COMMITTEE OF THE WHOLE JUNE 18, 2001

**SITE DEVELOPMENT APPLICATION
YORK REGION DISTRICT SCHOOL BOARD
FILE: DA.01.036**

ATTACHMENT "2"
SITE PLAN

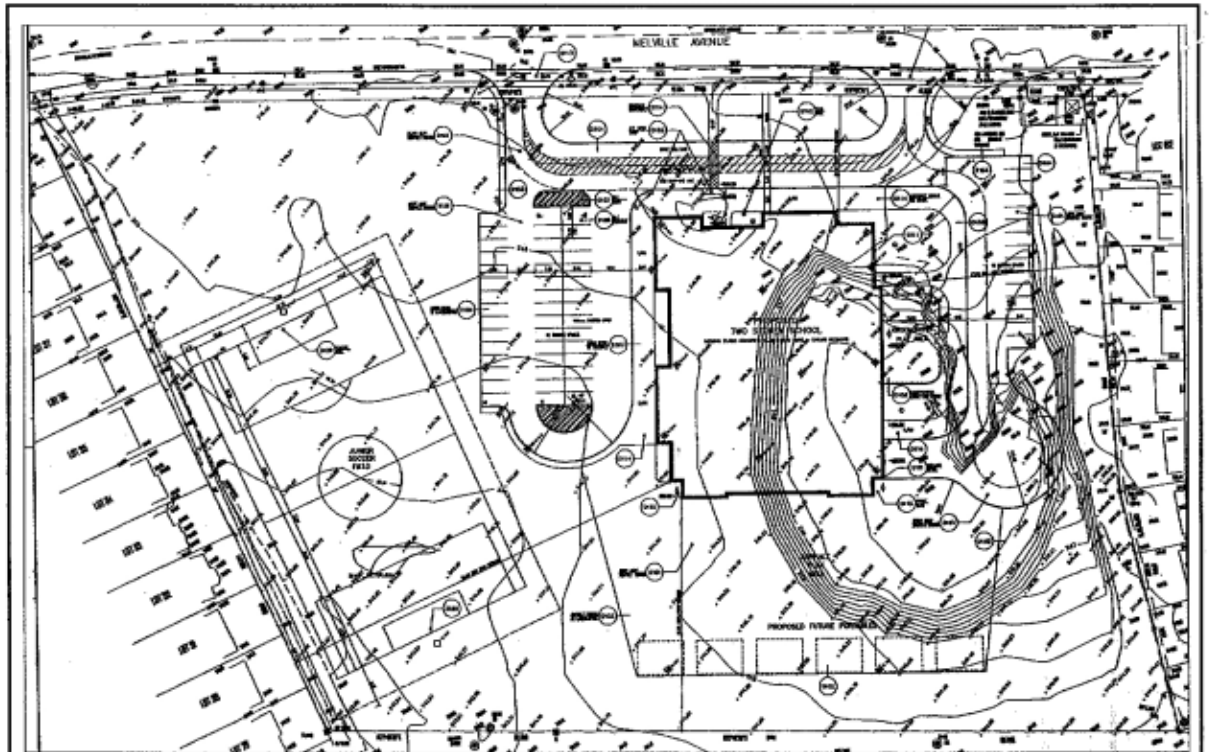
Pedestrian access is provided by walkway connections from Melville Avenue. Staff recommend that the Applicant consult with the Urban Design Department to determine if a walkway connection from Cranston Park Avenue, through the future Mackenzie Glen District Park, is possible. This walkway should be constructed with a different paving material, which will clearly identify the pedestrian walkway and create a safer environment for pedestrians.

Vehicular access to the site is provided from Melville Avenue, opposite Sandway Crescent and Maple Meadows Lane. A one-way driveway is proposed along the front of the building, which includes a bus lay-by lane, a "kiss and ride" drop-off lane, and a thru-lane. Appropriate signage should be posted to identify the one-way driveway to ensure its proper operation. Buses and other vehicles will enter the site from the west access, travel along the front of the school, drop off the children, and exit the site via the most easterly access. Staff recommend that the proposed accesses be revised, in consultation with Engineering Staff to clearly delineate the access of buses and vehicles.

The proposed school is located next to the future Mackenzie Glen District Park and therefore, the Urban Design Department will review the proposed landscape plan and details to ensure compatibility with the landscaping in the park. Appropriate landscaping should be provided along

the limits of the site to adequately screen the parking lot and loading area from the residential lots fronting onto Cranston Park Avenue.

ATTACHMENT "3"
ELEVATIONS

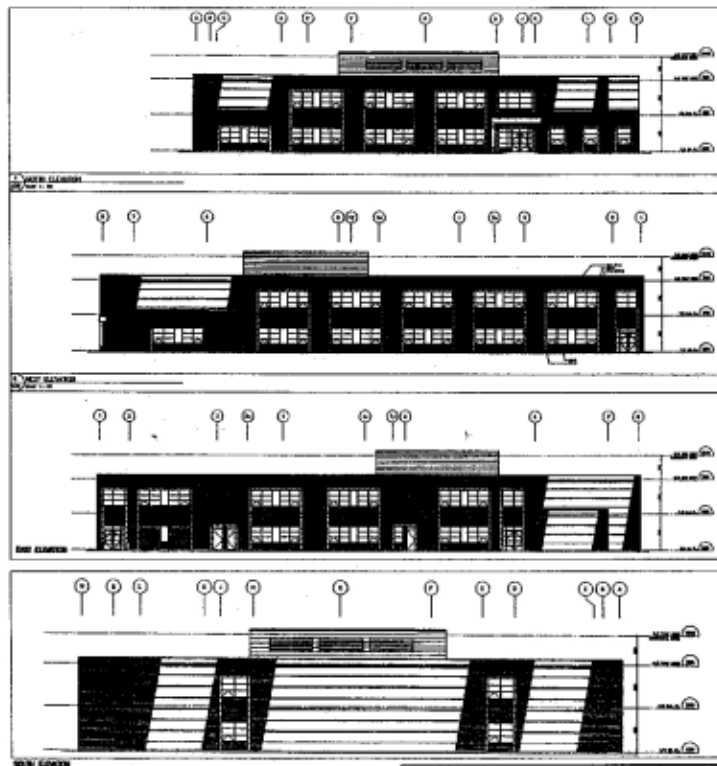
The south elevation, facing the future Mackenzie Glen District Park, consists of a broad wall with four windows. Staff recommend that this elevation be upgraded through increased fenestration and the introduction of additional building material or other design options.
